**ADA TOWNSHIP PLANNING COMMISSION
THURSDAY, JUNE 15, 2017 MEETING, 7:00 PM
TOWNSHIP OFFICES, 7330 THORNAPPLE RIVER DR.
ADA, MICHIGAN**

TO: Ada Township Planning Commission
FROM: Brent M. Bajdek, Planner/Zoning Administrator
RE: June 15, 2017 Agenda Items

- 1. Site Plan Review, Land Division Creating 5 Lots in the RP-1 District, 3333 and 3345 Egypt Valley Ave. NE, 6052 3 Mile Rd. NE, and 3204 Pettis Ave. NE, Parcel Nos. 41-15-05-200-008, 41-15-05-200-021, 41-15-05-400-017, and a portion of 41-15-05-100-045, Darren and Jill Herweyer**

<p>HERWEYER PROPERTY</p> <p>Proposed Private Road</p> <p>3333 Egypt Valley Ave, NE</p>	<p>SUMMIT SURVEYING, INC. P.O. Box 410 Allendale, MI 49401 Phone (616) 895-7190</p>
<p>DATE: May 18, 2017</p> <p>JOB NUMBER: 07/17/16</p> <p>SCALE: 1" = 250'</p> <p>SHEET 1 OF 1</p>	<p>DRAWN BY: RHL</p>

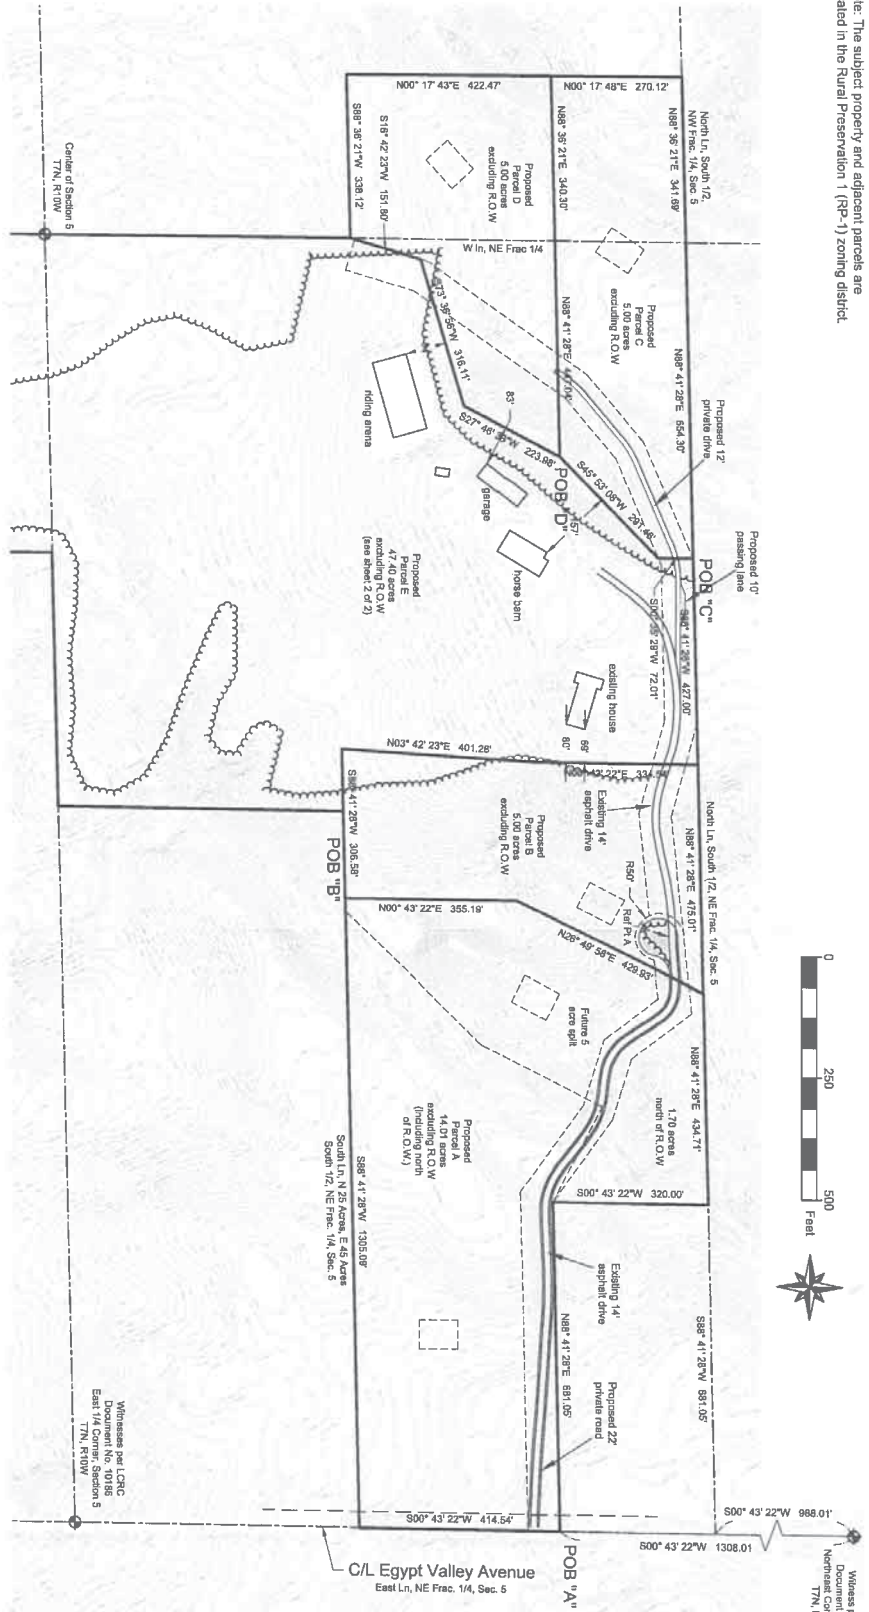
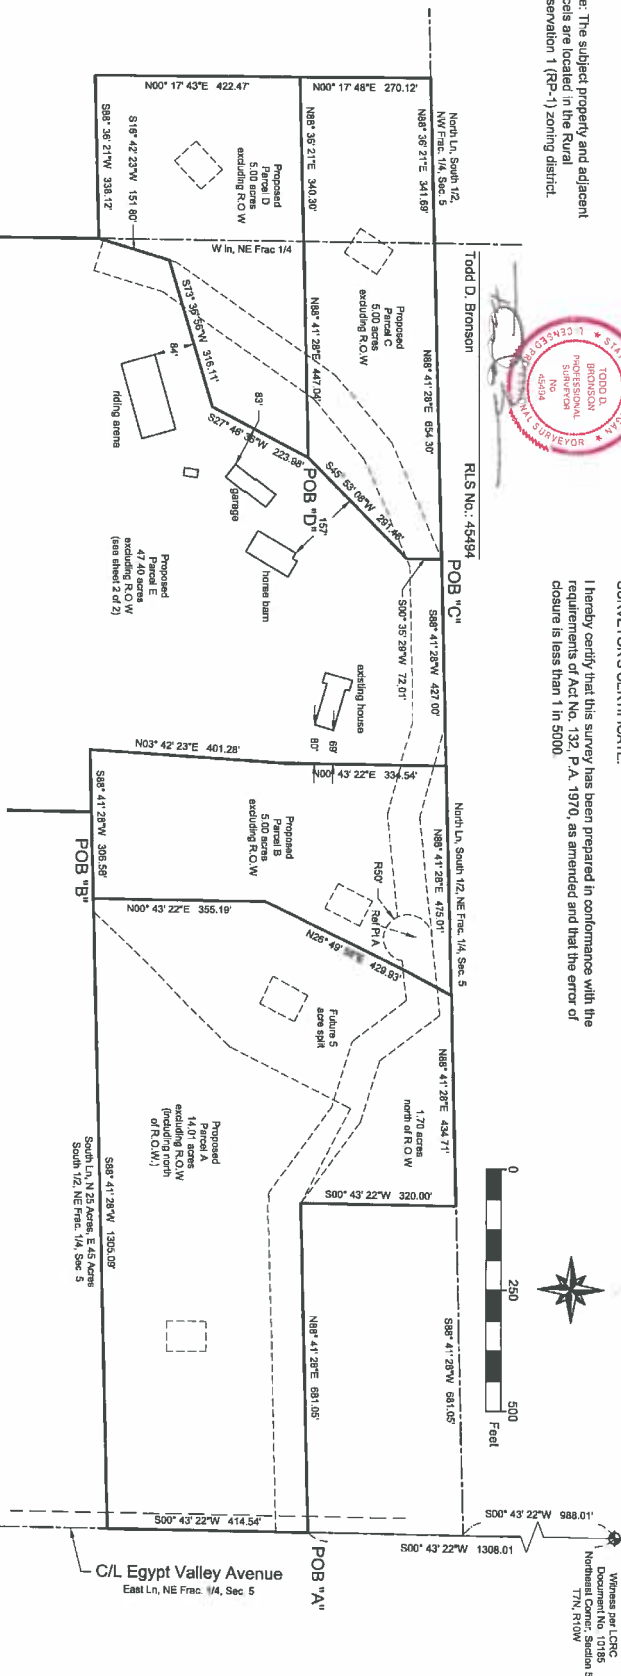
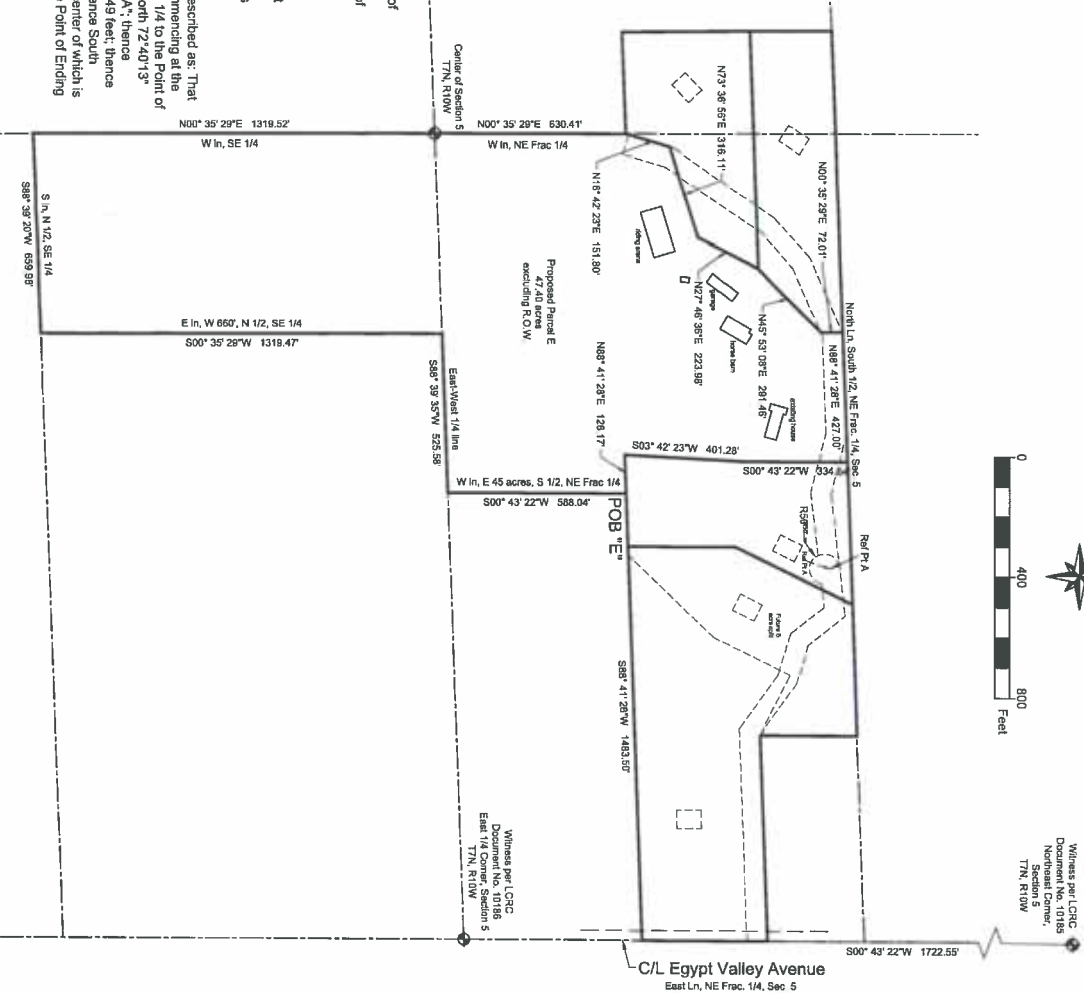
- (6) The size, shape and arrangement of lots and building envelopes shall be such that the following objectives, to the maximum extent practical, are accomplished, in the judgment of the planning commission:
- a. Building envelopes are located such that they are least visible from the adjoining public road and adjoining properties.
 - b. Building envelopes are located such that excavation for buildings and access drives avoids wetlands, steeply sloped areas and other sensitive natural features, and such that natural vegetated buffers are maintained adjacent to wetlands and streams.
 - c. Building envelopes are located to avoid placement of buildings on prominent hilltops and ridgelines, in order to maintain scenic views and the natural visual qualities of the township.

The lots and private road layout conform to all applicable zoning regulations. Approval of the land division plan is recommended, subject to the following conditions:

1. A Township Private Road Permit application, complying with Kent County Road Commission requirements and providing for construction of the emergency vehicle turn-around area as shown on the plan, shall be submitted and issued, prior to recording of the land division.
 2. Required private road and driveway access improvements shall be completed prior to issuance of building permits on Lots A, B, C and D.
 3. The grade of the private road shall not exceed ten (10) percent or a variance request granted from such requirement.
- 2. Request for Special Use Permit for 21,000 sq. ft. of Additional Building Space and Parking**
